# SERVICE BULLETIN

B-099

## BUELL 1125 MODELS CHARGING SYSTEM UPGRADE PRODUCT PROGRAM 0507

Figure 1. Stator Connector [47B] and Harness Routing

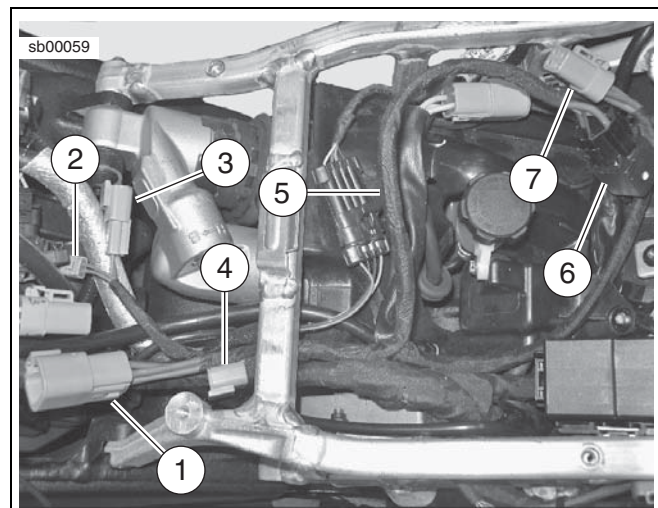
1. See Figure 1. Disconnect:
  - a. The stator connector [47] (1)
  - b. The active intake solenoid connector [178] (2)
2. Cut the cable strap securing the main harness to the subframe.
3. See Figure 1. Pull the voltage regulator stator connector socket housing [47B] (2) back under the subframe cross member and route the wire harness (3) along the DC lead to the voltage regulator connector [77] (4).

1. Stator connector [47A] pin housing
2. Voltage regulator stator connector [47B] socket housing
3. Wire harness
4. Voltage regulator harness to connector [77]

Figure 2. Relay Sub-Harness and Connectors

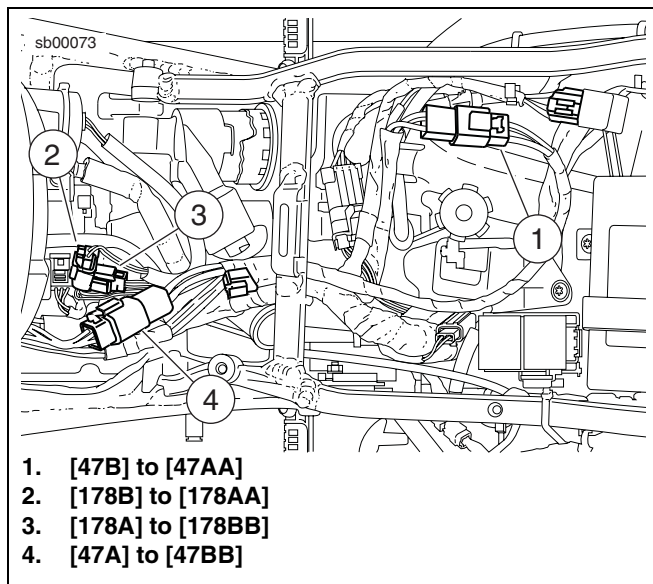
1. See Figure 2. Install and route the sub-harness:
  - a. The 4-place socket housing [47BB] (1), the 2-place socket housing [178BB] (2), the 2-place pin housing [178AA] (3), and the 2-place ECM lead socket housing [360A] (4) forward under the subframe cross member
  - b. The relay sub-harness (5) and the relay (6) along the side of the voltage regulator harness
  - c. The 4-place pin housing [47AA] to the stator connector (7) on top of the starter solenoid cover and the main harness fuse block branch
2. See Figure 3. Connect the housings:
  - a. [47AA] to [47B] (1)
  - b. [178AA] to [178B] (2)
  - c. [178BB] to [178A] (3)
  - d. [47BB] to [47A] (4)

1. [47BB]
2. [178BB]
3. [178AA]
4. [360A]
5. Relay sub-harness
6. Relay [260B]
7. [47AA]

**Figure 4. CAL Models: Relay Cable Straps**

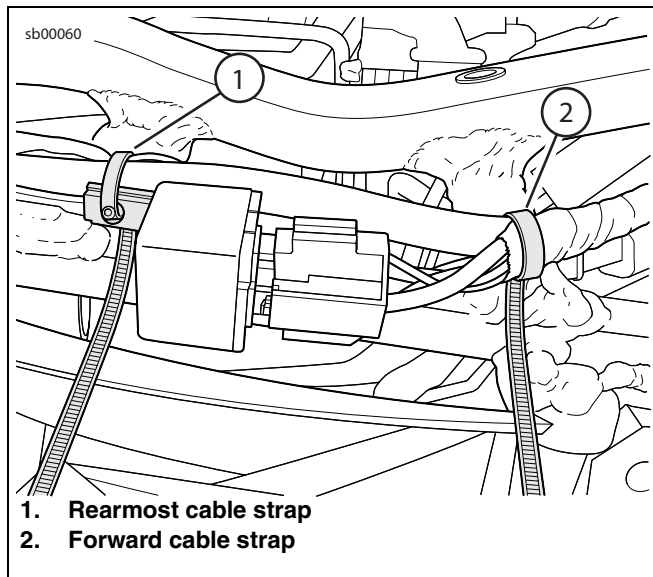
1. **CAL Models:** Install the relay:
  - a. Route the relay and harness through the right side subframe.
  - b. Replace the two clips around the battery cable and ground with barbed cable straps (Part No. 10177).
  - c. See Figure 4. Orient the relay mounting tab and strap the sub-harness to the battery cable and the ground at the rearmost cable strap (1).
  - d. Strap the relay harness branch to the battery cable at the forward cable strap (2).
  - e. Trim the cable straps flush.

**Figure 5. Non-CAL Models: Clamp Fastener and Cable Strap**

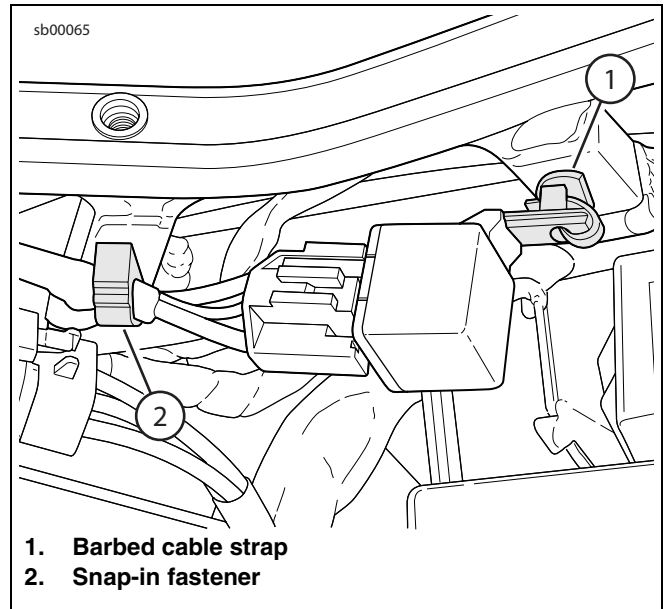
2. **Non-CAL Models:** Install the relay:
  - a. Install the snap-in fastener in the subframe upright.
  - b. Cable strap a barbed fastener to the hole in the relay mounting tab.
  - c. See Figure 5. Push the barb (1) into the hole in the subframe upright.
  - d. Clamp the relay wire harness in the snap-in fastener (2).
  - e. Trim the cable strap.

**Figure 7. Unwrap Engine Harness Tape**

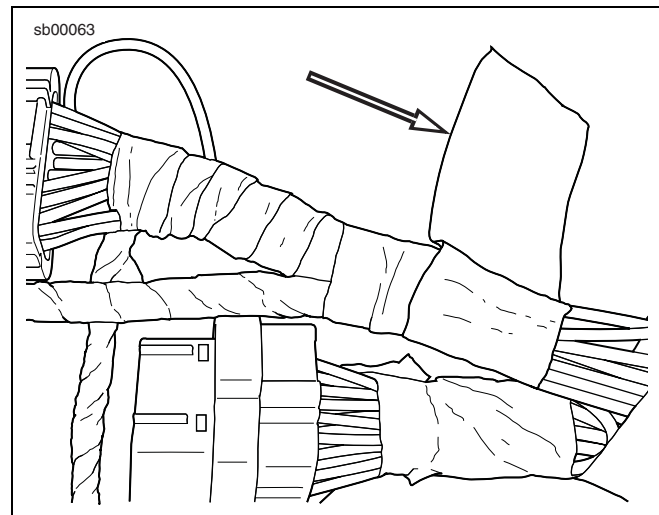
1. Route the ECM lead:
  - a. Bend a 0.40 in (1 cm) hook at the end of a length of mechanic's wire 36 in (91 cm) long and hook the socket terminal of the ECM lead.
  - b. See Figure 6. Insert the mechanic's wire between the left side of the frame and the rear cylinder head (1).
  - c. Angle the mechanic's wire to exit over the top of and in front of the engine mount (2).
  - d. Thread the mechanic's wire through the PVC sleeve on the engine harness (3) and pull the ECM lead through the PVC sleeve.
  - e. Separate the ECM lead from the mechanic's wire and remove the mechanic's wire.
2. Disconnect the J1 [11B] gray and J2 [10B] black connectors from the ECM.
3. See Figure 7. Unwrap the engine harness tape from the PVC sleeve to the J2 [10B] black connector.

**Figure 8. ECM J2 [10B] Black Connector Cavity 21**

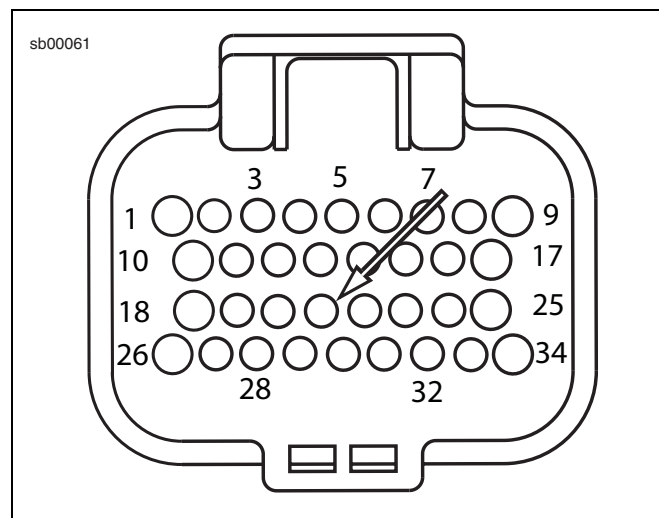
4. Install the ECM lead terminal in the ECM J2 [10B] connector:
  - a. Bend back the wires to access the cavity.
  - b. See Figure 8. Remove the white seal pin from cavity 21.

- c. Push the ECM lead terminal into cavity 21 until it stops.

**Figure 9. ECM J2 [10B] Black Connector Terminal Lock**

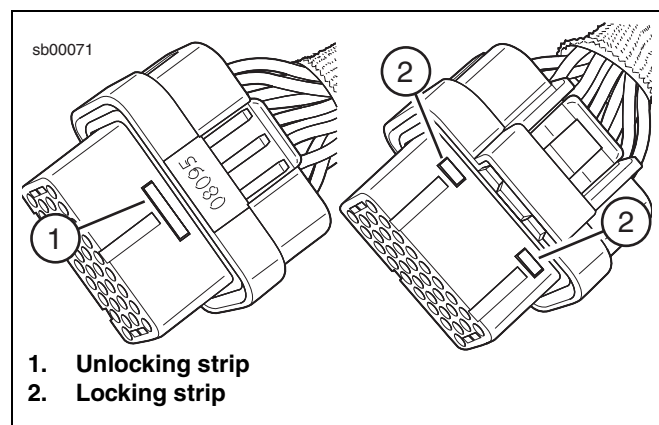
- d. See Figure 9. To unlock the terminals, push in the white strip (1) until it clicks.

- e. Seat the ECM lead terminal.
  - f. To lock the terminals, push in the two white pins (2) on the side opposite the white strip.
5. Wrap the harness tape around the engine harness and the ECM lead.
  6. Connect the ECM J1 [11B] gray and J2 [10B] black connectors to the ECM.
  7. Connect the ECM lead socket connector housing [360B] to the relay sub-harness pin connector [360A].

Figure 10. Cable Strap Locations

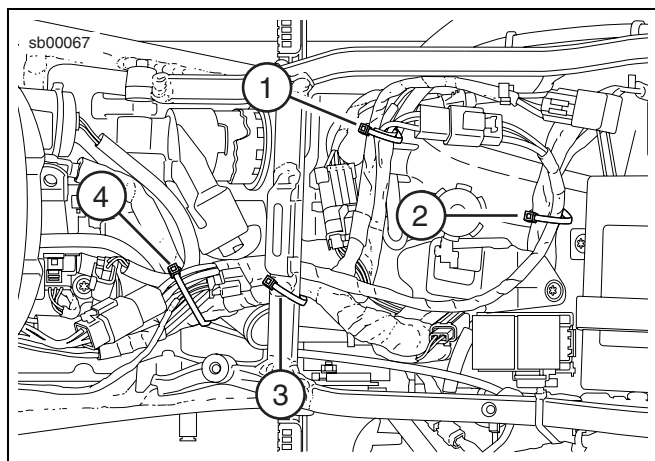
1. See Figure 10. Cable strap the relay wire harness, the wire harness and the connector, [47B] to [47AA], and the negative battery cable to the voltage regulator DC lead (1).
2. Cable strap the stator connector wire lead to the main wire harness fuse block wire lead (2).
3. Cable strap the sub-harness stator connector pin housing, the main wire harness, and the starter power cable to the subframe cross member (3).
4. Cable strap the ECM lead to the main harness, the sub-harness, and the active intake convolute tubing (4).
5. Trim the cable straps flush.
